FINAL ENVIRONMENTAL ASSESSMENT
FOR
LIHUE REFUSE TRANSFER STATION

PREPARED BY:
GMP ASSOCIATES, INC.
FOR
KAUAI COUNTY PUBLIC WORKS DEPARTMENT

RESPONSE TO REVIEW COMMENTS

Response to our Comments
Environmental Assessment/Negative Declaration
Lihue Refuse Transfer Station, Lihue Kauai

FIGURE 3
SITE 3 - SITE PLAN
SCALE: 1" = 500'

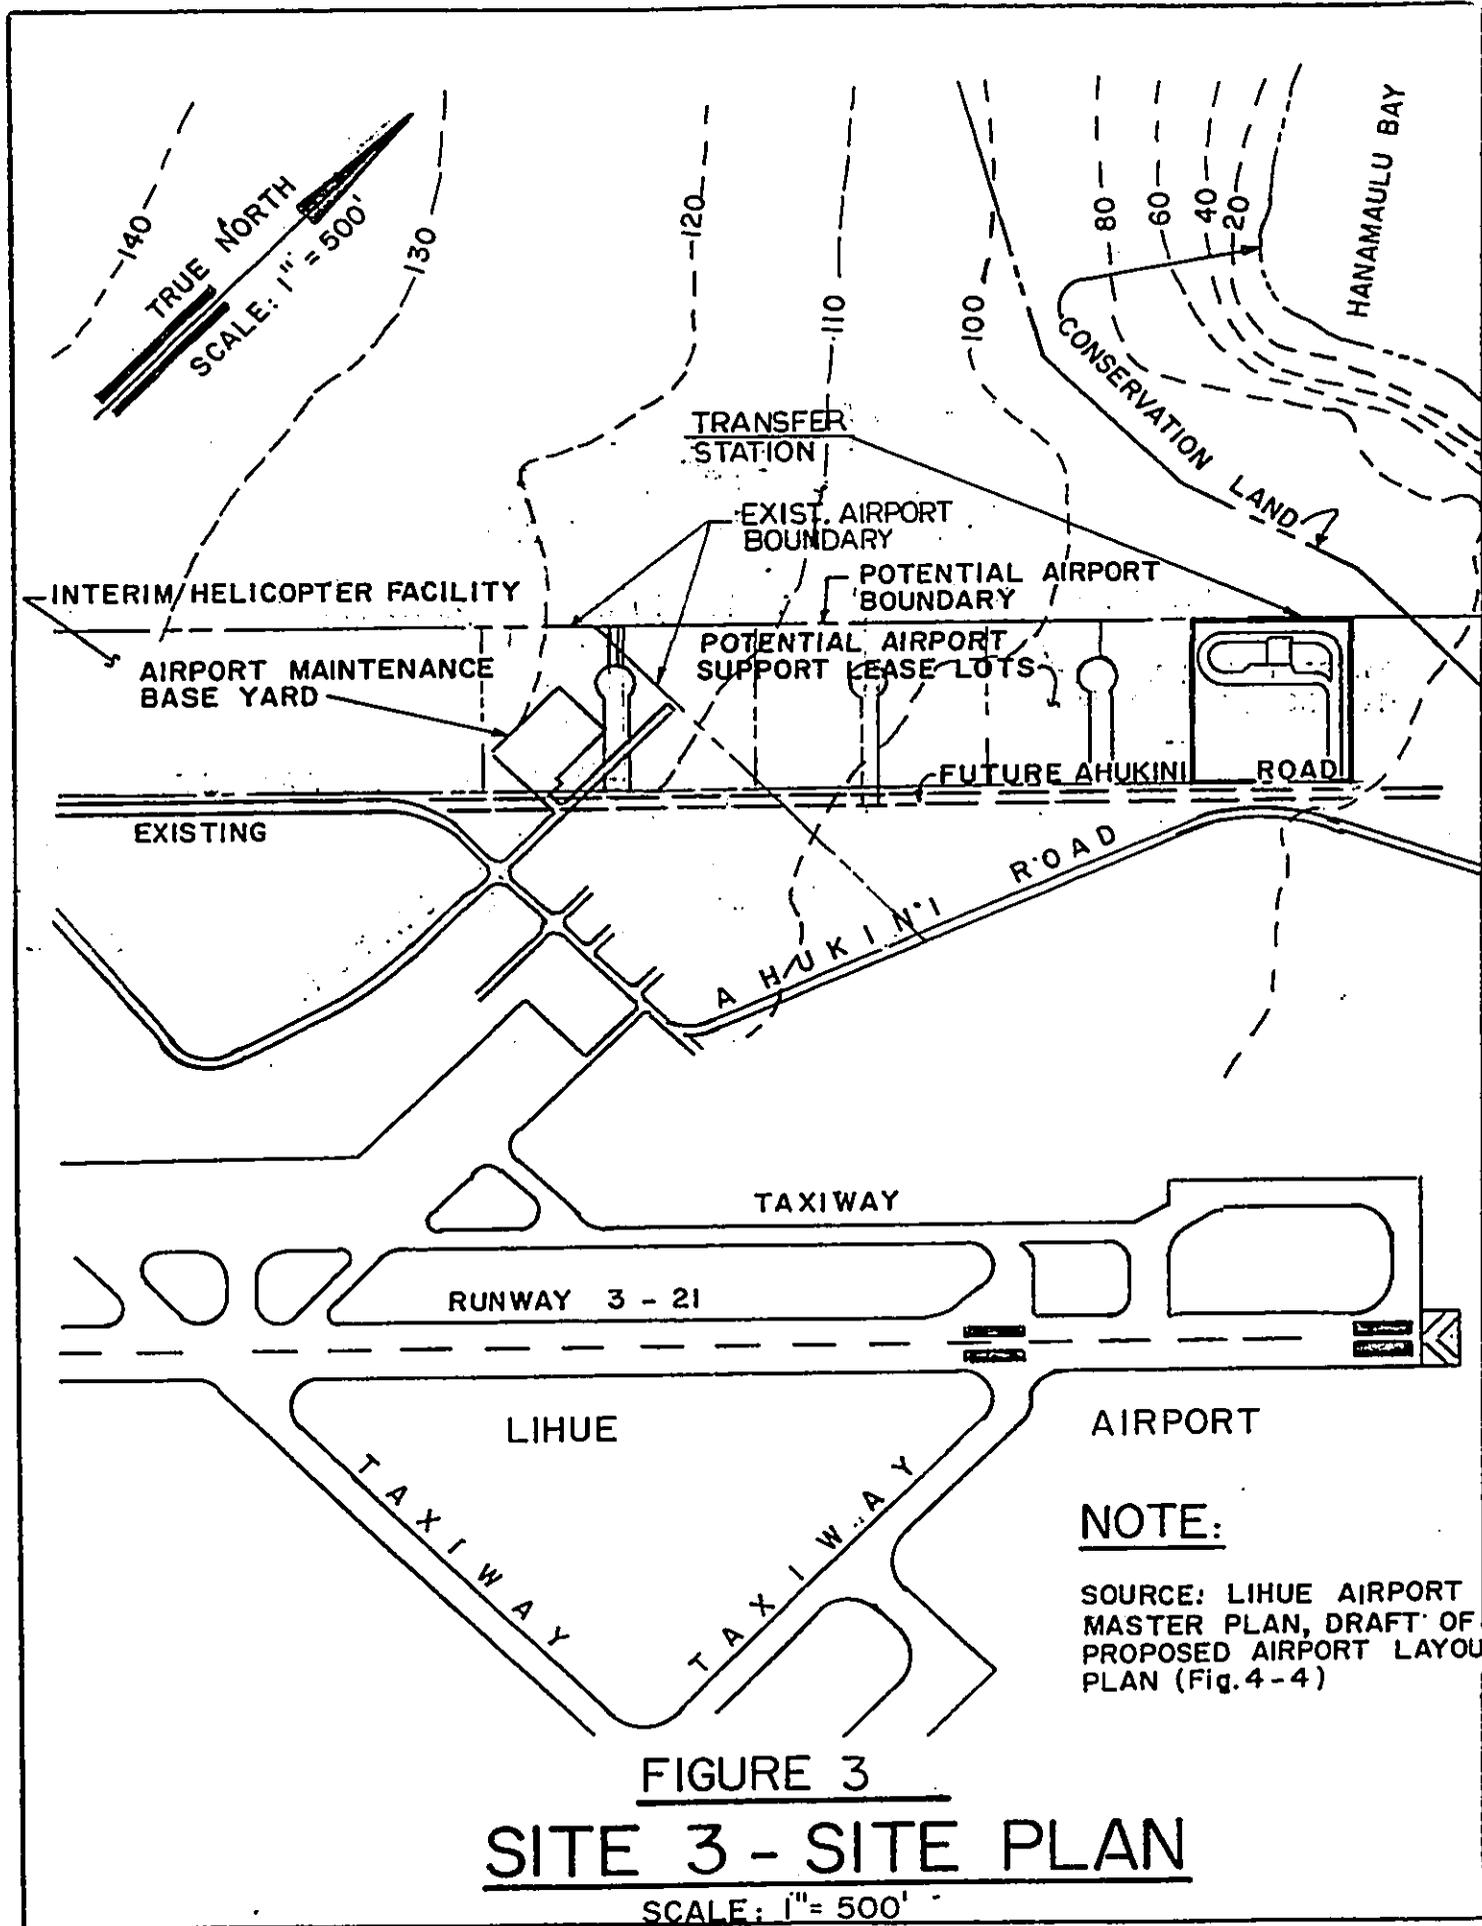
R - Tax Map Key and size of project site are noted in the final EA report: TMK 3-7-02, 3.8 acres. Revised Figure 3 of the final EA depicts the proposed location for the transfer station. The term "shortly" was revised to "within three years." The term "just north" was revised to "north by northeast." At the time the EA was submitted in September 1989, the exact parcel for the transfer station in the vicinity of the airport area was not identified. Since then, the exact location, metes and bounds for the parcel have been determined.
